AN timeout and fast restart mechanism

Adee Ran, Cisco

Overview

Table 119-2a--AN_LINK.indication(link_status) generation

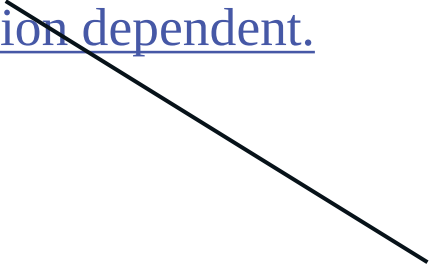
The PCS shall support the AN_LINK.indication(link_status) primitive (see 73.9). The parameter link_status shall take ~~the value FAIL when PCS_status=false and the value OK when PCS_status=true~~ one of the values FAIL, IN_PROGRESS, or OK, according to Table 119-2a.

The primitive shall be generated when the value of link_status changes.

172.6 and 175.7
can refer to this
table.

Figure 178B–8—Training control state diagram

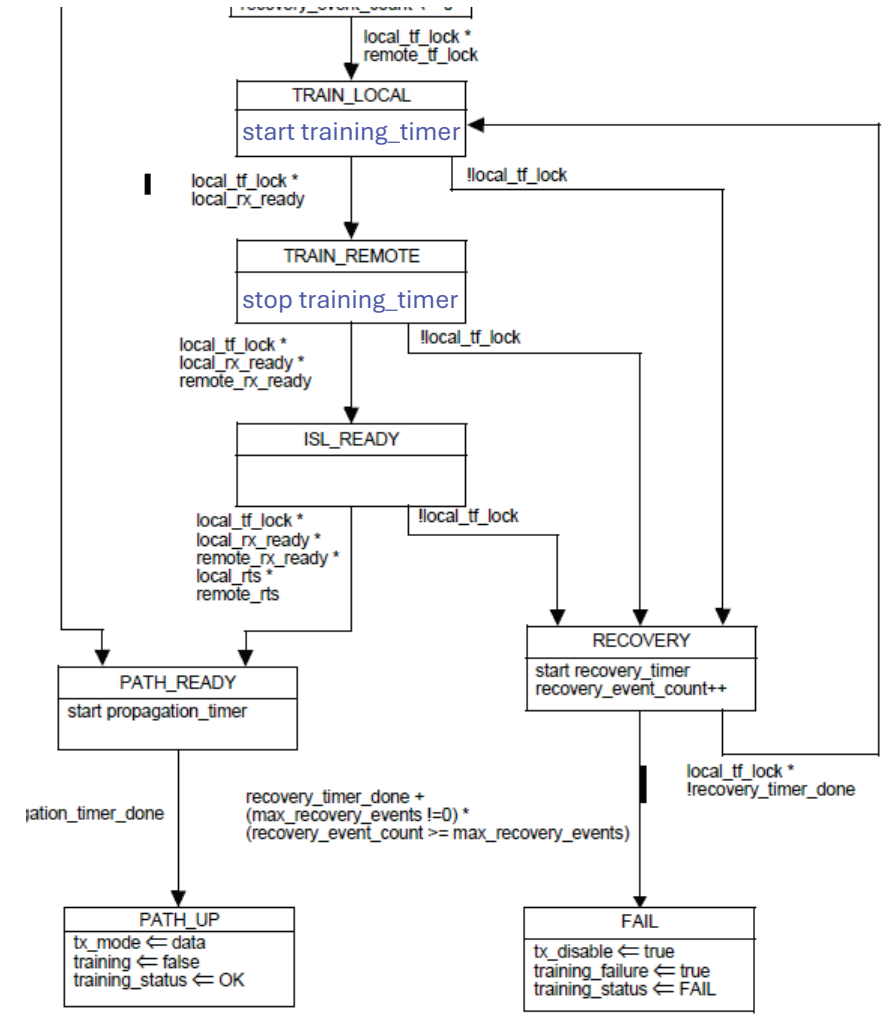
Modify Figure 178B-8, adding a timer, as follows:
In the Train Local state, add "start training_timer".
In the Train Remote state, add "stop training_timer".

`training_timer`

This timer is started when the training control state diagram on a lane enters the TRAIN_LOCAL state (see Figure 178B–8). The terminal count of this timer is controlled by the management variable `mr_training_timer_duration`. The effect of expiration of this timer is implementation dependent.

Add MDIO mapping for **`mr_training_timer_duration`** (RW) and **`training_timer_done`** (RO) in Table 178B–6 and in Clause 45.

Add default values of `mr_training_timer_duration`: in clauses 178 and 179 – 60, in annexes 176C and 176D – 0.
